Docket Item # 1 BAR CASE # 2011-0333

BAR Meeting December 14, 2011

ISSUE: Window Replacement

LOCATION: 401 North Fayette Street

Figure 1. Existing conditions, front (west) and rear (east) elevations.

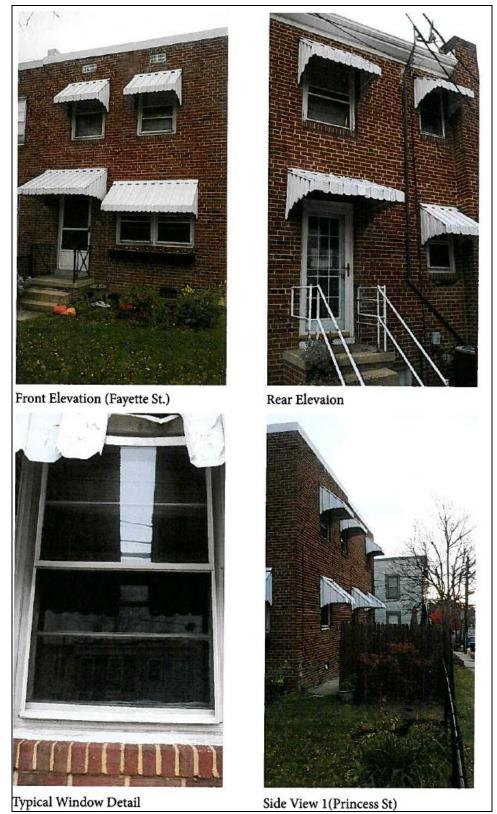
The applicant is requesting approval of a Certificate of Appropriateness for replacement windows at 401 North Fayette Street. The applicant is requesting approval to replace existing single-glazed, two-over-two (horizontal muntin) wood windows with one-over-one, aluminum-clad wood windows. The proposed windows are Pella double-glazed, full-frame, aluminum-clad wood windows.

STAFF RECOMMENDATION: Staff recommends approval of the application as submitted.

Figure 3. Proposed window specifications.

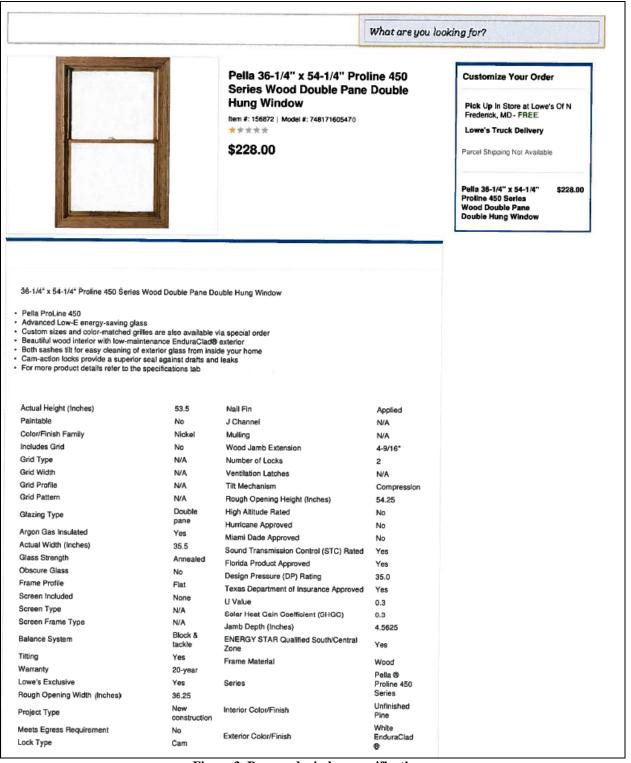
Aluminum-clad wood windows became commercially available in the 1969 and therefore may be administratively approved on buildings constructed after 1969, according to the recently adopted Window Policy. However, because of the 1962 date of construction of this unit, Staff was unable to administratively approve aluminum-clad windows. Staff has no objection to the use of aluminum-clad wood windows in this particular case finding that they are in keeping with the architectural style and materials associated with this building type. Indeed, many of these buildings were originally constructed with steel sash windows. Furthermore, Staff notes that for this type of resource—the ubiquitous, vernacular, red brick townhouse of the mid-20th-century the significance of these buildings in Alexandria lies not in one specific building material. The significance of this building type is generally cultural, rather than architectural, and exemplifies the model used to house a great influx of workers during and after World War II. This townhouse style proliferated because its simple design could be adapted to a variety of conditions and ornamented and differentiated in numerous ways, and it used common, readilyavailable materials. In consideration of this, Staff finds that the use of aluminum-clad wood windows continues the spirit of using readily-available, durable materials for this type of building.
